8 May 2023

The Chief Executive Officer  
Northern Beaches Council  
Attention: Mr Alexander Keller

**STATEMENT OF ENVIRONMENTAL EFFECTS - ADDENDUM  
122 & 124 Queenscliff Road QUEENSCLIFF  
DA2022/0646 - Amendments**

**Figure 1 – height blanket image of the proposed building showing the locations and extents (400mm, 750mm and 800mm) of the proposed exceptions with the 8.5m height plane based on the ‘Merman’ method of measurement**

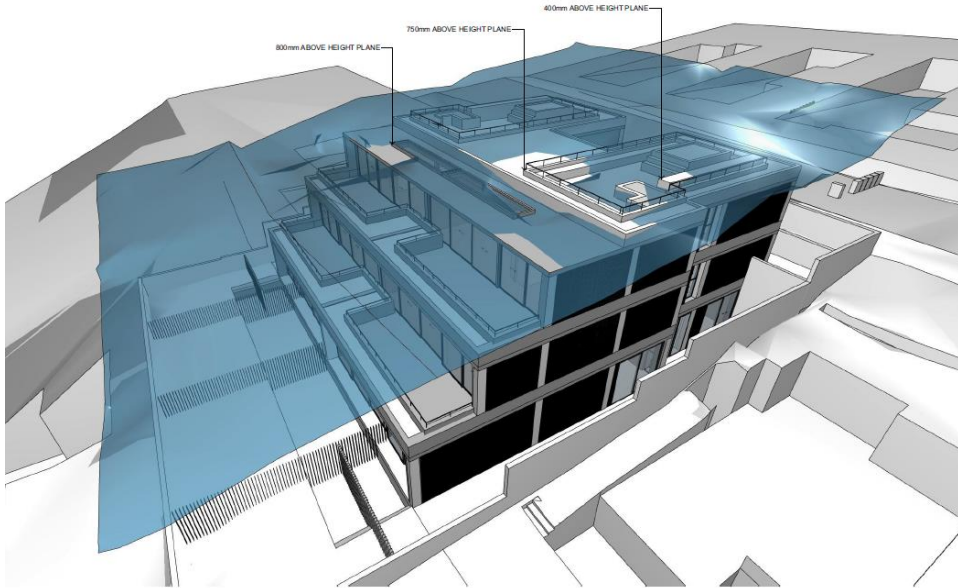
The method of calculating the building height has been revised to address the Commissioner's judgment in *Merman Investments Pty Ltd v Woollahra Municipal Council* [2021] NSWLEC 1582. Height plane diagrams have been provided for both 8.5m above natural ground level, as well as finished floor of existing basement floors as per the Merman method.

- the existing building height exceeds the development standard as shown within the architectural plans.
- the proposed building height is variable and extends up to 9.3m above the existing ground level (figure 1).
- the proposed building height represents an exception ranging from 400mm up to 800mm or up to 9% of the development standard, and only in small horizontal sections, as shown in figure 1.
- A clause 4.6 exception request for building height is submitted addressing this matter.

Figure 3 – the proposed front setback alignment is compatible with the adjacent development

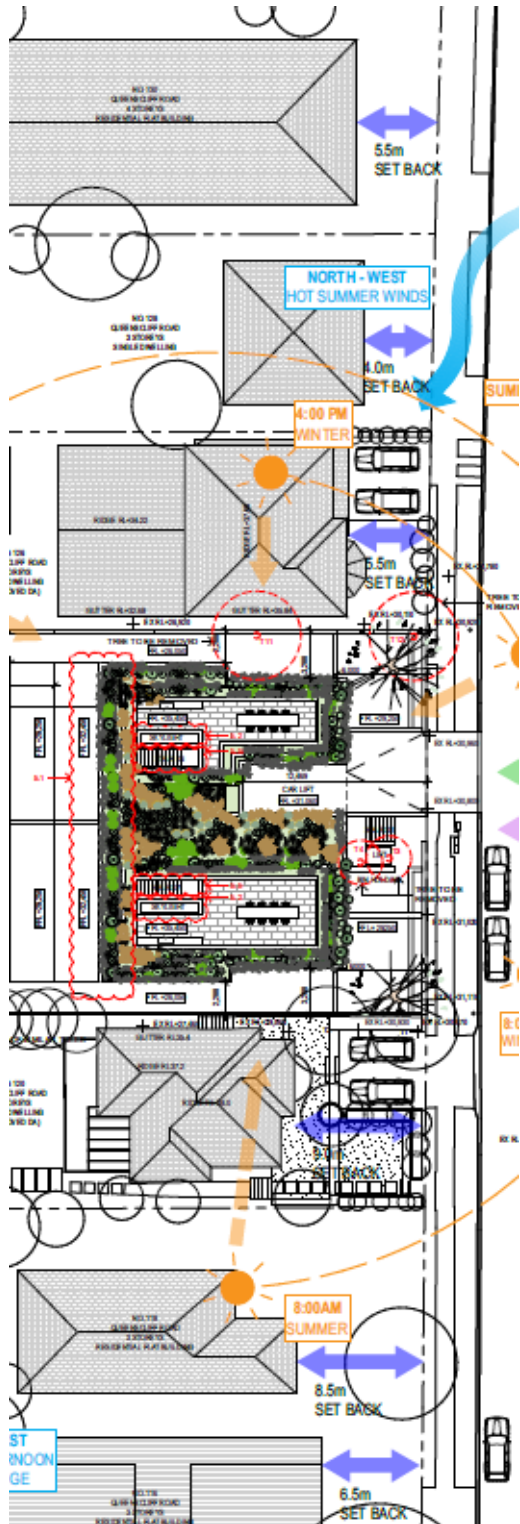
- The proposed front setback has been increased from 6m to 6.2m and provides a compatible frontage to Queenscliff Road as depicted within figure 3.
- The proposed development exceeds the minimum rear setback requirement and by concentrated the development closer to the site frontage reduces its shading impact on the rear private open spaces within the adjacent properties.
